SUBJECT: ISSUANCE OF AMENDMENT FOR CALVERT CLIFFS NUCLEAR POWER PLANT
UNIT 1 (TAC NO. 79709)

CALVERT CLIFFS NUCLEAR POWER PLANT, UNIT 1

Amendment No. 151
License No. DPR-53

SAFETY EVALUATION BY THE OFFICE OF NUCLEAR REACTOR REGULATION

Figure 3.1-1b

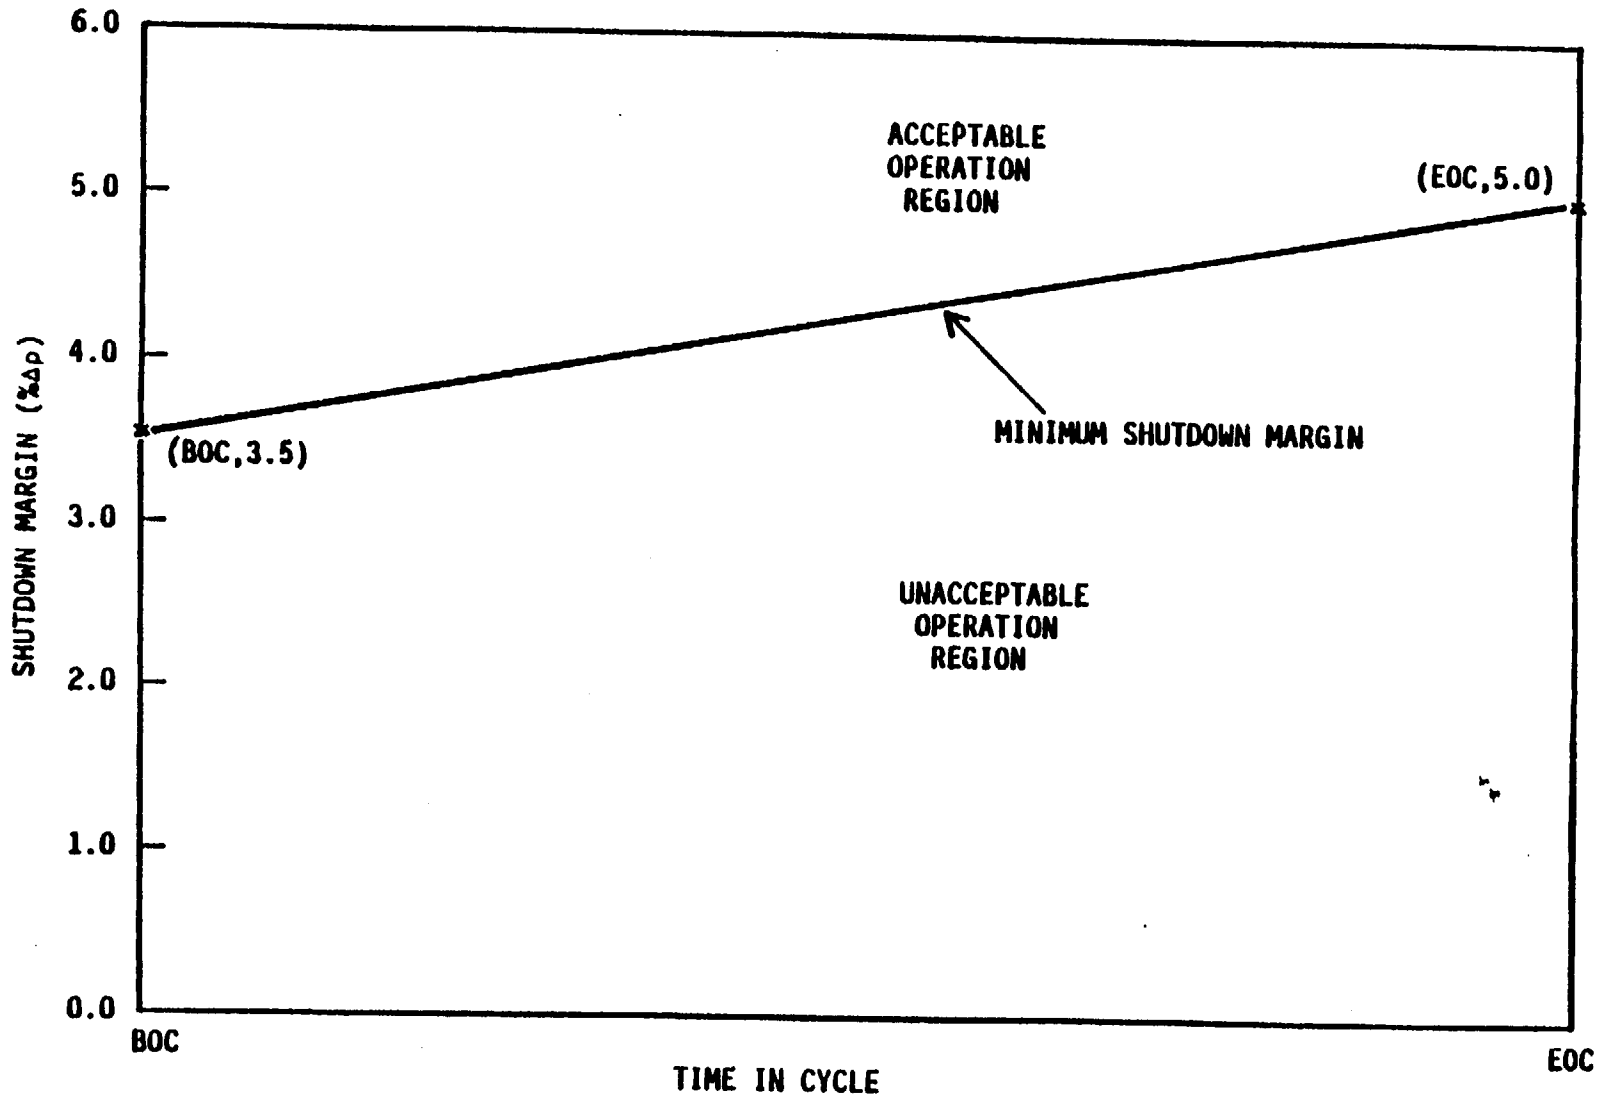
4.1.1.1.1 The SHUTDOWN MARGIN shall be determined to be equal to or greater than the limit of Figure 3.1-1b:

- a. Within one hour after detection of an inoperable CEA(s)⁺ and at least once per 12 hours thereafter while the CEA(s)⁺ is inoperable. If the inoperable CEA is immovable or untrippable, the above required SHUTDOWN MARGIN shall be increased by an amount at least equal to the withdrawn worth of the immovable or untrippable CEA(s)⁺.
- b. When in MODES 1 or 2[#], at least once per 12 hours by verifying that CEA group withdrawal⁺ is within the Transient Insertion Limits of Specification 3.1.3.6.
- c. When in MODE 2^{##}, within 4 hours prior to achieving reactor criticality by verifying that the predicted critical CEA position⁺ is within the limits of Specification 3.1.3.6.
- d. Prior to initial operation above 5% RATED THERMAL POWER after each fuel loading, by consideration of the factors of e below, with the CEA groups⁺ at the Transient Insertion Limits of Specification 3.1.3.6.

+ Excluding the center CEA during Cycle 10.
